MEMORANDUM

DATE: **February 24, 2014**
TO: **Plan Holders**
FROM: **Ronald J. Pritzlaff, Utility Engineer**
RE: **Addendum No. 1**

The Utility has issued Addendum No. 1 to our Howell Avenue Water Main Relay project. You can download a copy of the addendum from our web site at:

Revised Plan Sheets 1, 2, 3, 4, and 5

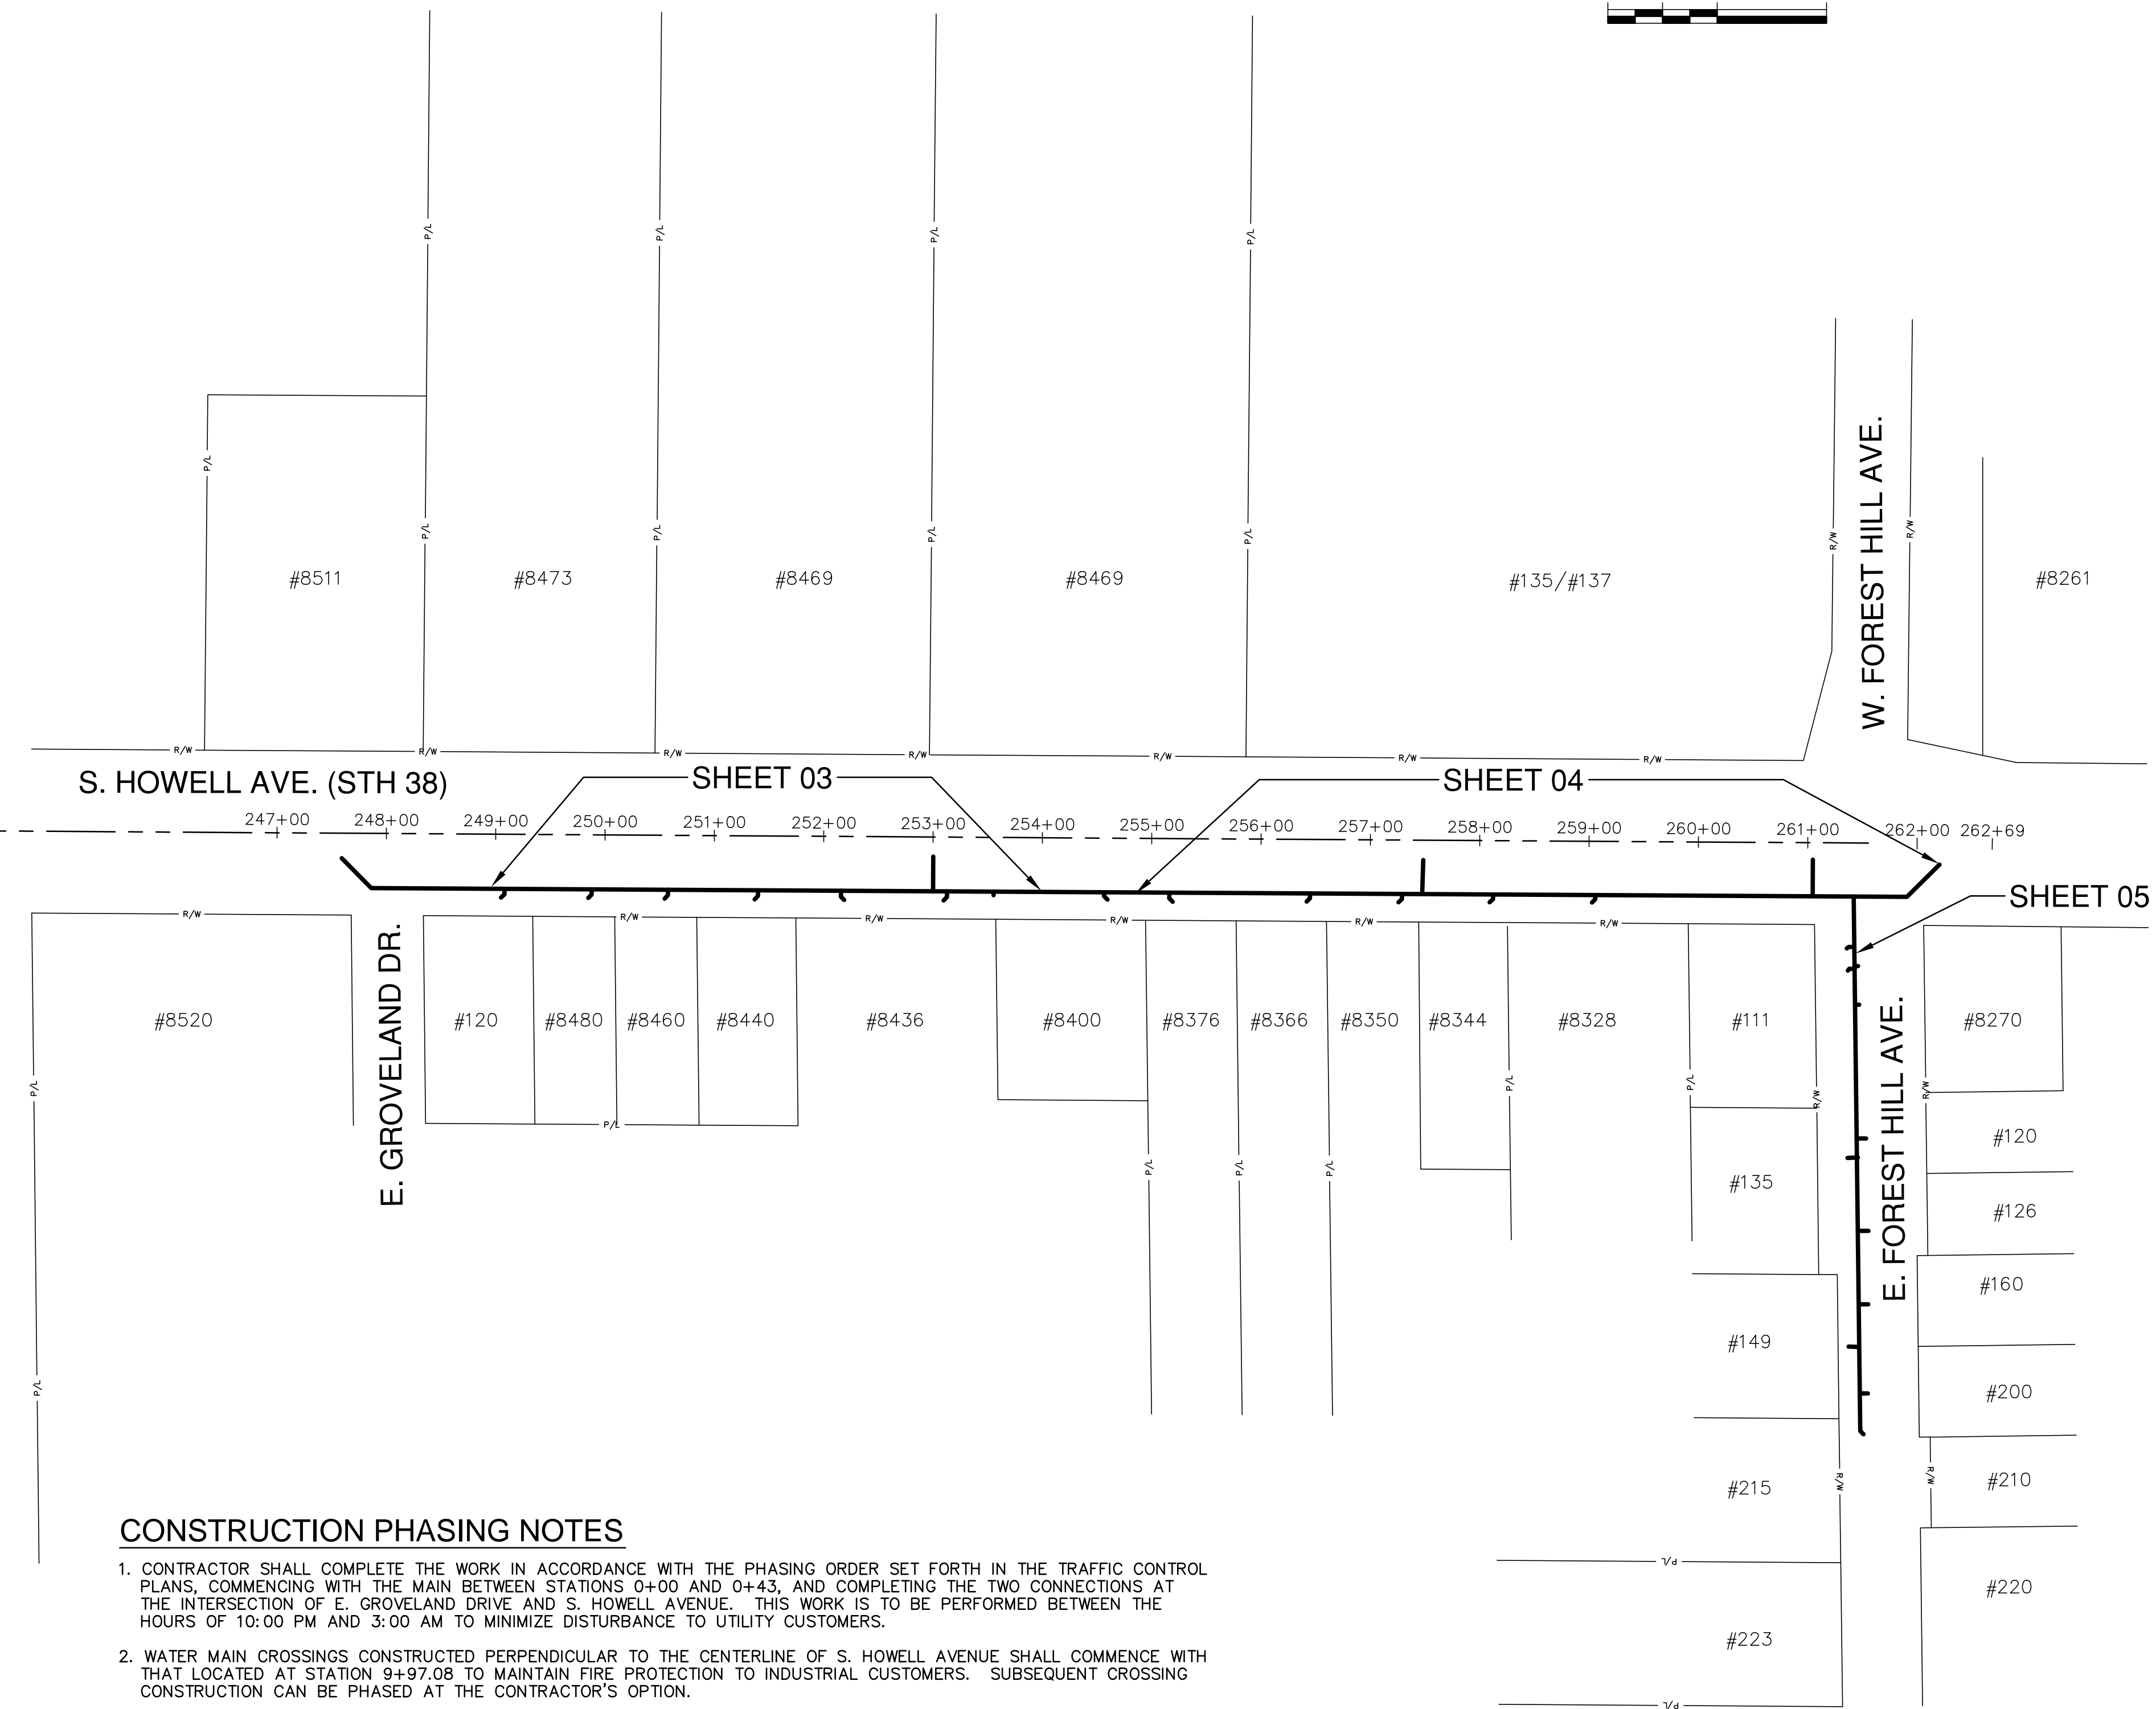
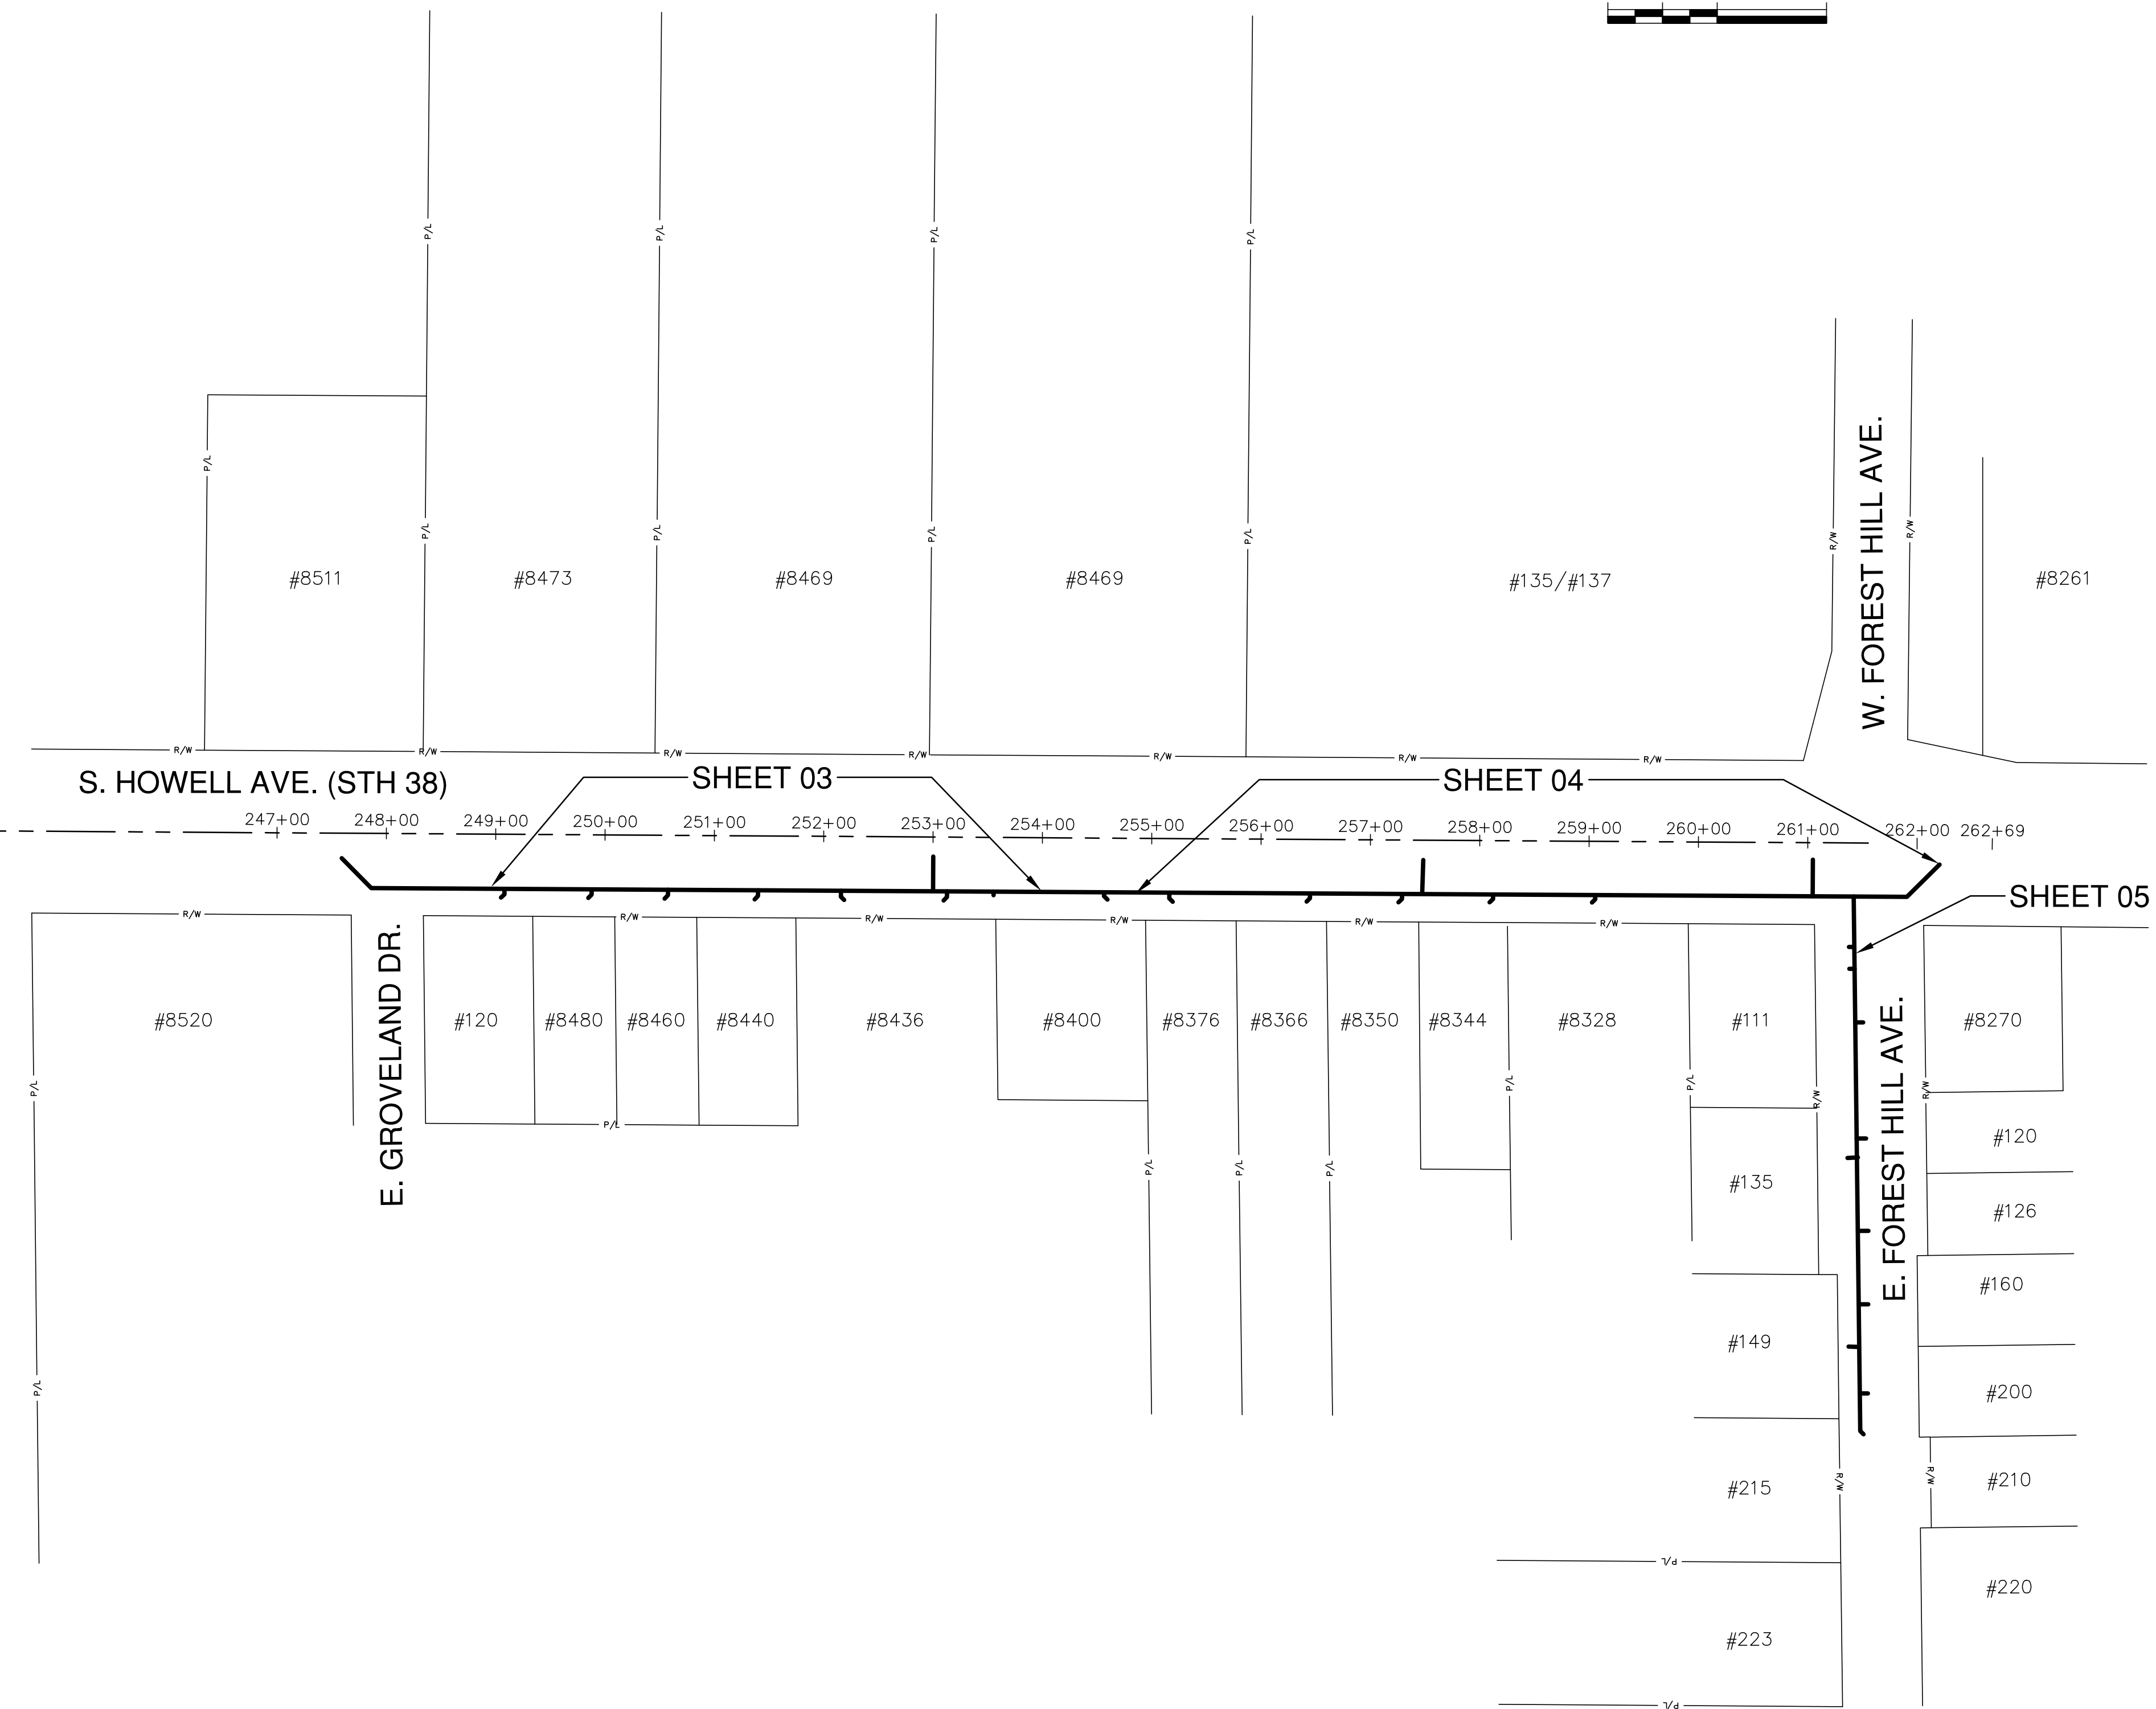
- Replace Schedule One of the Bid Proposal Section in its entirety
- Replace Section VII MATERIALS FOR WATER MAINS, paragraph H in its entirety
- Delete Section VIII MATERIALS GENERAL, paragraph A in its entirety
- Replace Section VIII MATERIALS GENERAL, paragraph B, sub-paragraph 1 in its entirety
- Replace Section X RESTORATION IN THE WORK AREA, paragraph C, sub-paragraph 1 in its entirety
- Replace Section X RESTORATION IN THE WORK AREA, paragraph C, sub-paragraph 2, part B in its entirety
- Replace Section XVI PROPOSAL ITEMS in its entirety
- Replace the Wisconsin Department of Transportation Utility permit in its entirety
- Replace sheet numbers 1,2,3,4, and 5 of the plans in their entirety

- BACKFILL LEGEND**
- (A1) 3/4"-INCH T.B.B.F. (TYPE A1)
 - (A8) GRANULAR BACKFILL (TYPE A8) OR SLURRY BACKFILL (SEE D.O.T. PERMIT)

- SURFACE RESTORATION**
- (H1) ASPHALT REPLACEMENT
 - (C1) CONCRETE REPLACEMENT W/ASPHALT OVERLAY
 - (C2) HIGH EARLY STRENGTH CONCRETE REPLACEMENT W/ASPHALT OVERLAY
